**Subject: Completion of ORNL AFCI Level 2 Milestone – CETE Investments and Hot Cell Upgrades (FY08) – OR0915020323, MS# M2502032302, “Secure Dissolver Off-gas Rack Authorization for Hot Operations,” due 6/30/2009**

Plan of Action and Readiness Review for Level 1 Readiness Assessment

**Activity Title:** Startup of Off-Gas Trapping for Hot Cell Dissolution

Readiness Review Checklist  
Plan of Action and Readiness Review for Level 1 Readiness Assessment

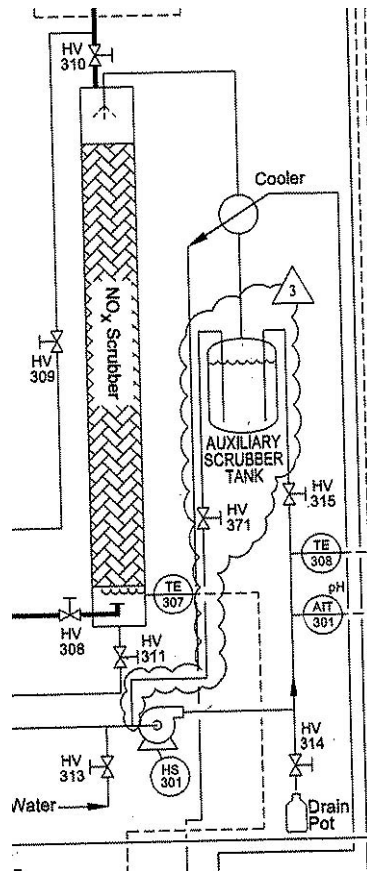
- The Compensatory Measure HEPA filter was installed on 06/19/09 in the existing return line. Field review of the HEPA (on 06/24/09) identified the HEPA filter as IE-2303. Don Foster (DAR) provided the documentation of the test/inspection records for this new filter.

- No further comments on the new HEPA filter.

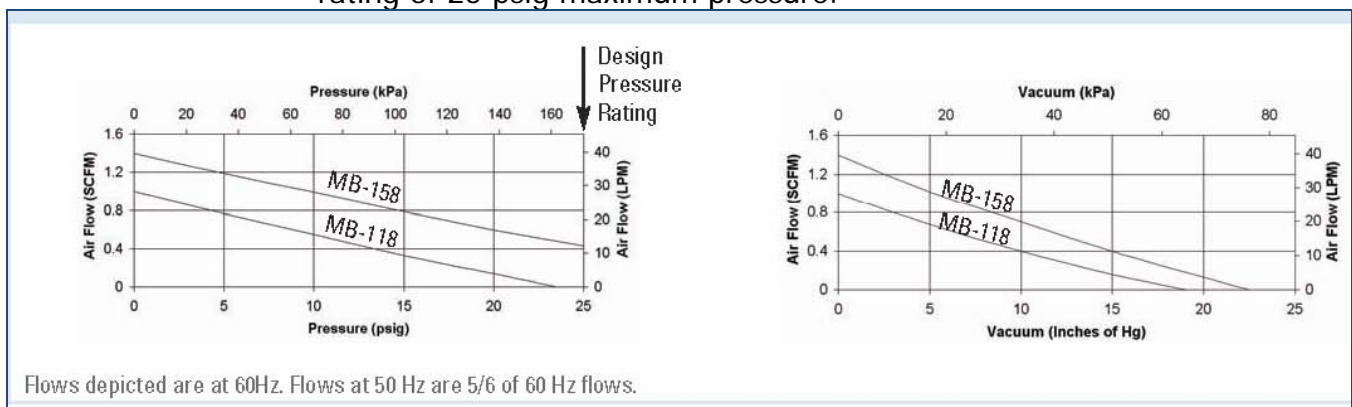
- A brief field review of the electrical components was conducted on 06/24/09.
  - Per Dean Campbell: *"The on/off switch for the pump is installed in a conduit box with knockouts and other openings. These type boxes are not allowed to be used for cord sets. A cast box with strain relief, or a listed in line cord switch is needed for the switch application."*

- The design/installation problems with the Temporary Recirculation Vacuum pump need to be corrected prior to operation. **[OBS-07]**
- The new vacuum pump has not been labeled, as of the field review at ~ 2:00pm on 06/24/09. **[OBS-08]**
